memorandum

Hawke's Bay Regional Council DATE 25 May 2021

RE Takapau WWTP Discharge Consent Review

Figure 9.1: Downstream contaminant mass load percentage contribution to Tapairu Bridge HBRC Monitoring Location for each development stage (Beca, 2021: T:D.25)

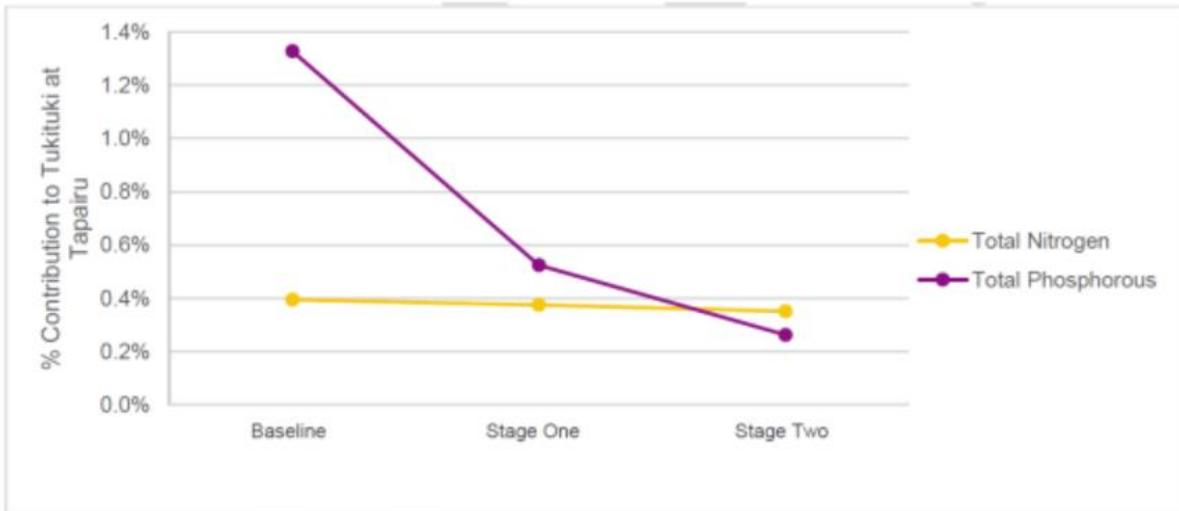
Nitrate is the primary nutrient of concern, due to the relatively low reduction across stages, as shown in the table and figure provided by BECA in the application.
